California Public Utilities Commission
Energy Division

Clean Coalition Protest of
Utility Advice Letters re Rule 21, Qualifying
Facilities and the CREST program

July 26, 2011

Clean Coalition Protest on Utility Advice Letters

Figure 1. Comparing IOU WDAT and SMUD wholesale interconnection procedures, including construction.

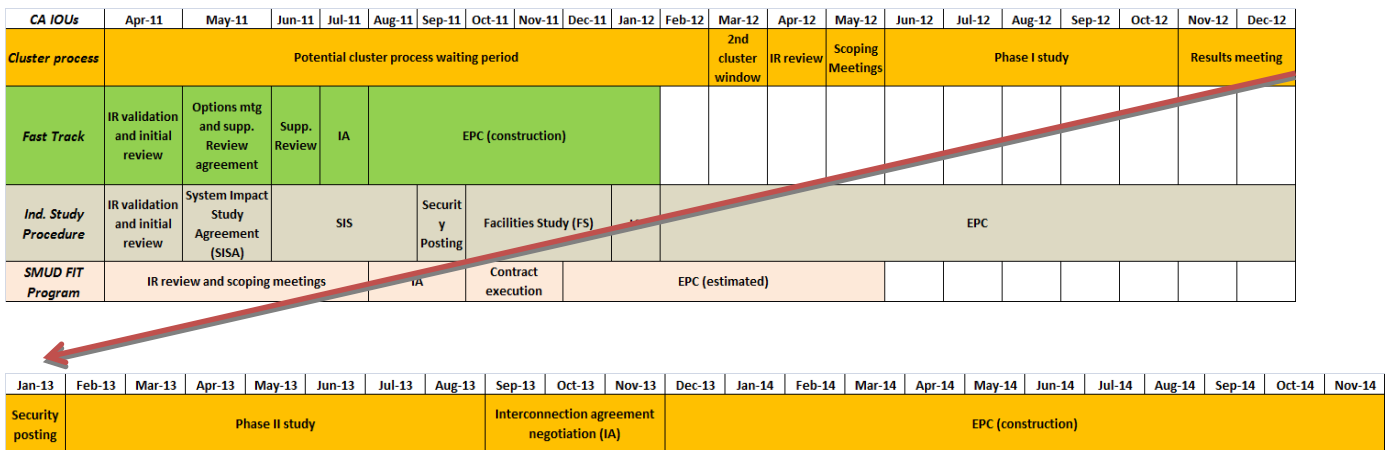
Rule 21 interconnection procedures have been revised over the last decade to better accommodate net-metered generation, but haven’t been modified sufficiently for wholesale projects. Interconnection of wholesale DG (as opposed to net-metered generation) has emerged as the key bottleneck for WDG when FERC-jurisdictional interconnection procedures are at issue. While Rule 21 for wholesale interconnection does indeed need reform, immediate reform is not necessary – particularly when the utilities are proposing to substitute inferior interconnection procedures than currently exist under Rule 21. (PPA reform under, for example, SCE’s CREST program is in fact a more pressing issue because the CREST PPA is currently not financeable, as many parties have advised SCE). The proposed interconnection cure would, in other words, be worse than the disease. See Figure 1 demonstrating the time frame for interconnection under the new WDAT/CAISO procedures, with a comparison to the far shorter time frame for SMUD’s interconnection procedures, including construction

time. SMUD is the clear leader in interconnection policies in California, judging by its actual experience interconnection its feed-in tariff projects, thus prompting our comparison.

SMUD: *About a year* total (with construction)
IOU cluster process (the default process): *3 to 3.5 years**

** Assumes applicants respond to IOU immediately, at each decision point, which will never be the case*
